H3K/519

APPLICATION FOR PERMISSION

(a) Proposed use(s)/development 擬議用途/發展	臨時公眾停車場(私家車)及填土工程 (Please illustrate the details of the proposal on a layout plan) (請用平面圖說明擬議詳情)									
(b) Effective period of permission applied for 申請的許可有效期	☑ year(s) 年 3

Drainage Impact Assessment on Proposed Surface Drainage Outflow (Rev. A)

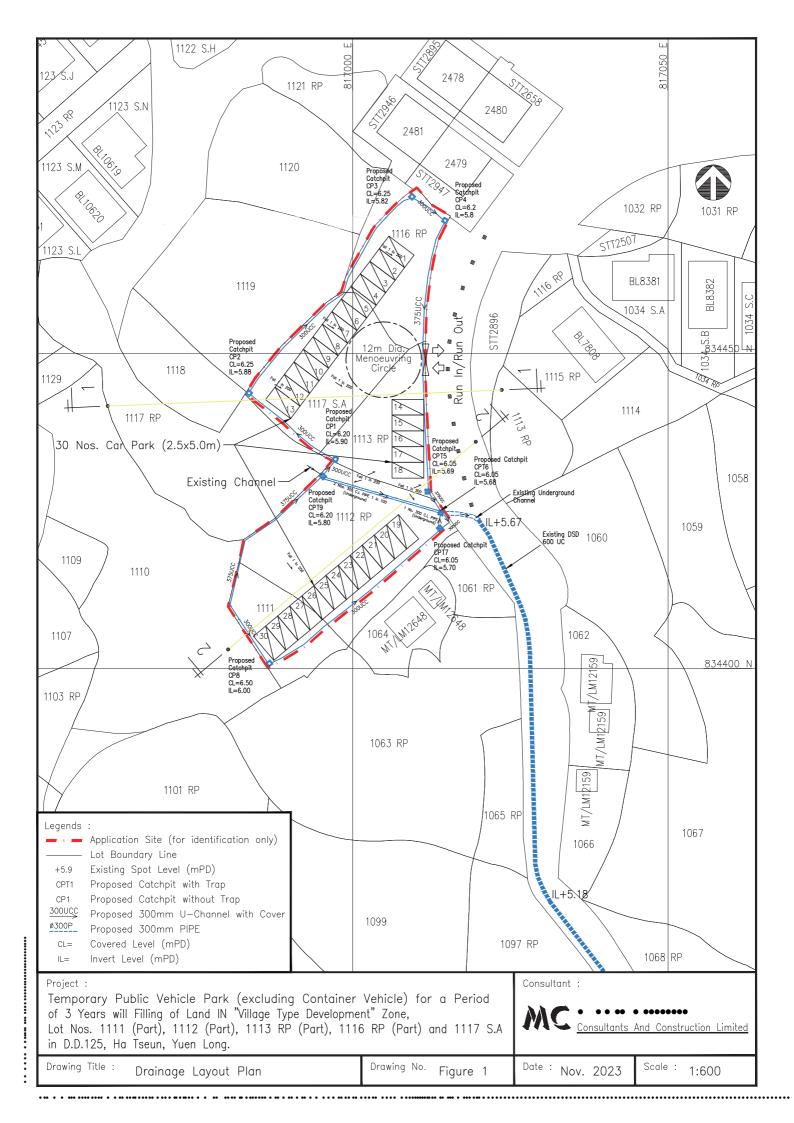
In response to DSD's comment, this report is prepared to

- (a) Identify the existing channel/gully and provide site record photos.
- (b) Demonstrate with hydraulic calculation that the proposed and existing drainage facilities are adequate to collect, convey and discharge the surface runoff.

The catchment collected by the terminal 600 UC maintained by DSD is as shown in the plan (scale 1 in 1000) in **Appendix B**.

According to the proposal, the existing 600 UC will collect more runoff from the northern side of the application site and increased runoff from paved surface for the whole application site.

In summary, the flow collected by the 600UC and the pipe is less than the design capacity. The capacity of the new constructed 375 UC and 300UC within the application is adequate.
